Department of Public Works
City Engineering Division

**NOTICE OF ADDENDUM
ADDENDUM NO. 01
CONTRACT NO. 7008
CENTRAL PARK – PHASE 1A**

CENTRAL PARK PHASE 1A

ADDITIONAL INFORMATION AND CLARIFICATIONS

2 BACKLESS BENCH
SCALE: 1/2" = 1'-0"

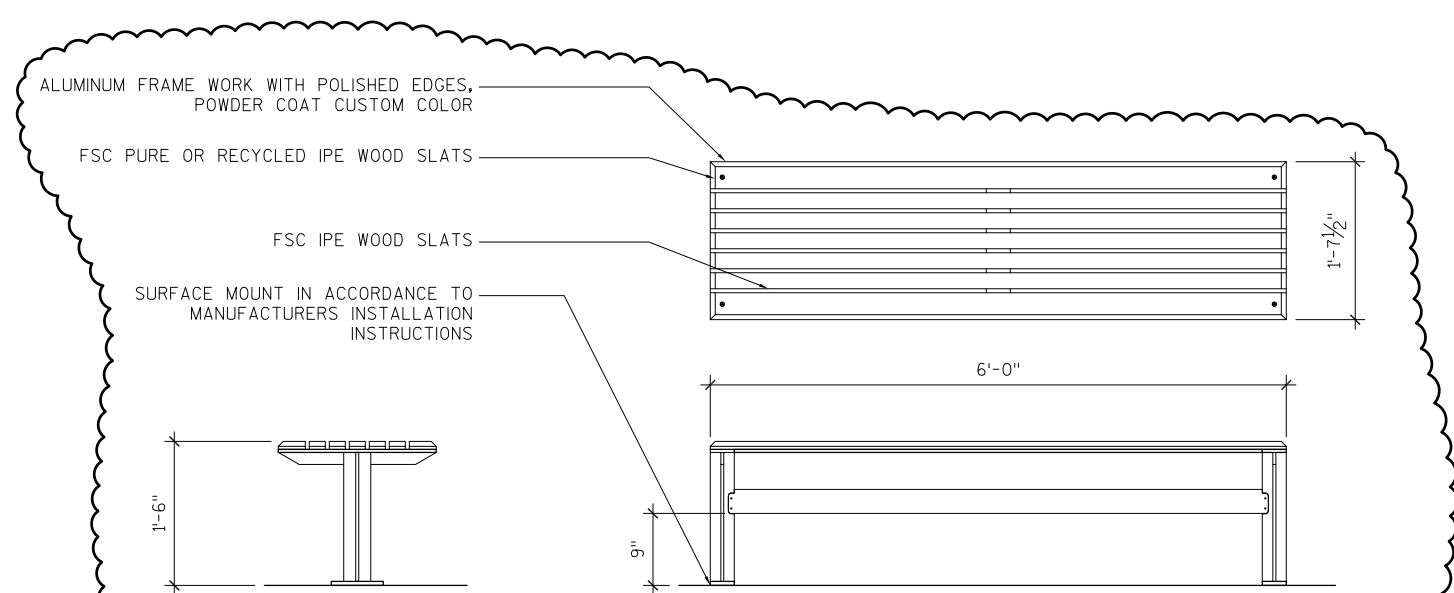
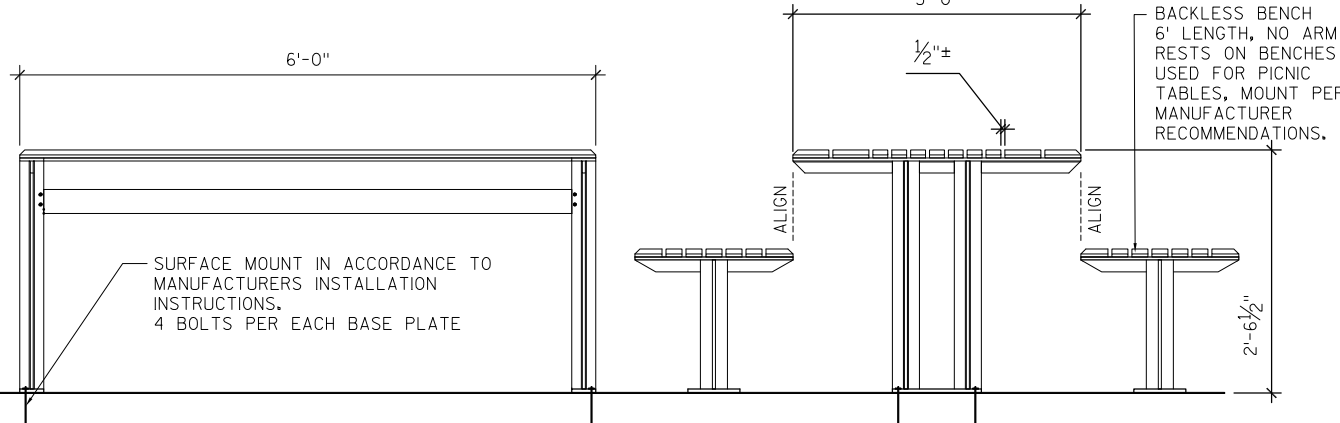
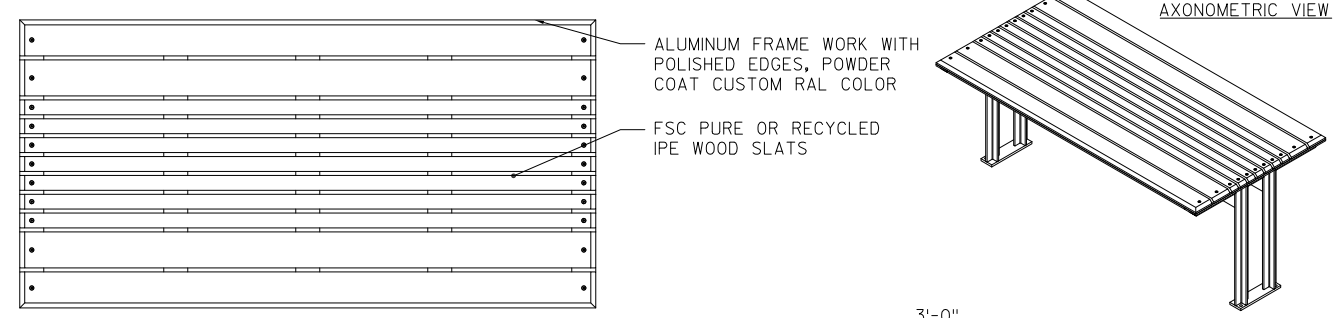
BID ITEM 90017 BENCH, BACKLESS

REVISE Materials as follows:

Furnish Forms+Surfaces (Pittsburgh, PA 1-800-451-0410, www.forms-surfaces.com) Knight Bench, 6' length, backless, surface mount, or approved equal. Seat Slats: FSC Pure Ipe hardwood, penetrating oil finish in color Penofin hardwood formula 'Transparent Natural'; Bench Frame: Solid aluminum with invisible welds; No Armrest; Frame Color: PT-TT02-HS16, Nutmeg CB, Mil Thickness = 3.8, Gloss = 2, Time/Temp = 10' @400 degrees F.
